Proposed Flat and Shop and Services Uses with Minor Relaxation of Plot Ratio Restriction at Lots 4614 and 4615RP in DD116, and Lots 1753sBRP (part), 1753sBss3 (part), 1756sA (part), 1756RP (part), 1757, 1758RP, 1760RP in DD120, and adjoining Government Land, Tai Kei Leng, Yuen Long

Sewerage Impact Assessment (Revision C)

December 2023

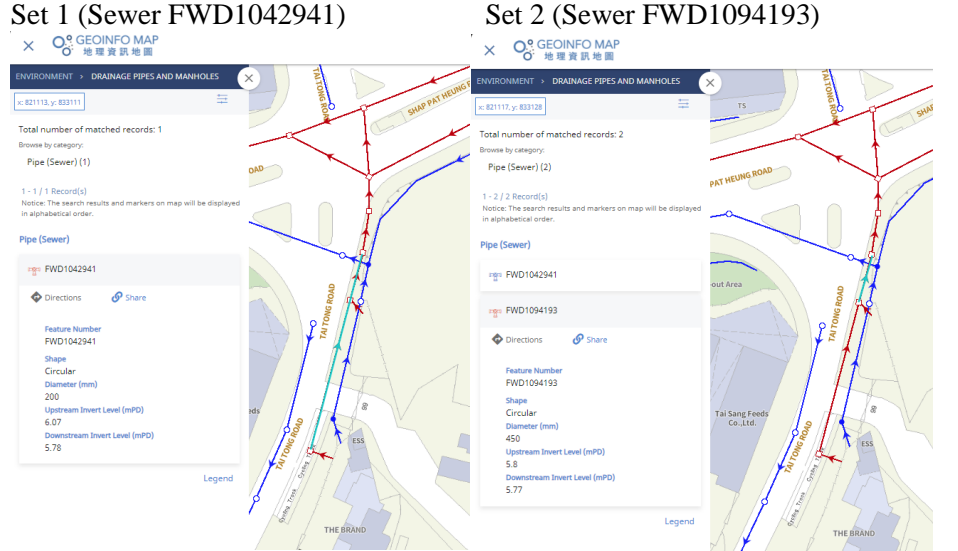
Items	Comments	Responds									
Comments from Environmental Protection Department dated 27 November 2023											
4. Sewerage Impact Assessment											
(a)	Appendix D3, D4, D5 and E: Please correct the pipe no. FWD1081044 to FWD1043909;	Appendices D3, D4, D5 and E are updated accordingly.									
(b)	Appendix D4: Please check peaking factor of pipe FMD-P2;	The peaking factor of pipe FMD-P2 is 5. Table 5.2 and Appendix D4 are updated.									
(c)	Appendix D5: Pipe full flow capacity and flow velocity of pipe FWD1043910 and FWD1043909 are inconsistent with that in Appendix D3 and D4. Please check; and	<p>The full flow capacity and flow velocity of pipes FWD1043910 and FWD1043909 in Appendix D5 are revised. The full flow capacity and flow velocity for pipes FWD1043910 and FWD1043909 are as follow: -</p>

<table><tr> <th>Pipe</th> <th>Pipe Full Flow Velocity (m/s)</th> <th>Utilization (%)</th> </tr><tr> <td>FWD1043910</td> <td>0.79</td> <td>41%</td> </tr><tr> <td>FWD1043909</td> <td>1.25</td> <td>18%</td> </tr></table>
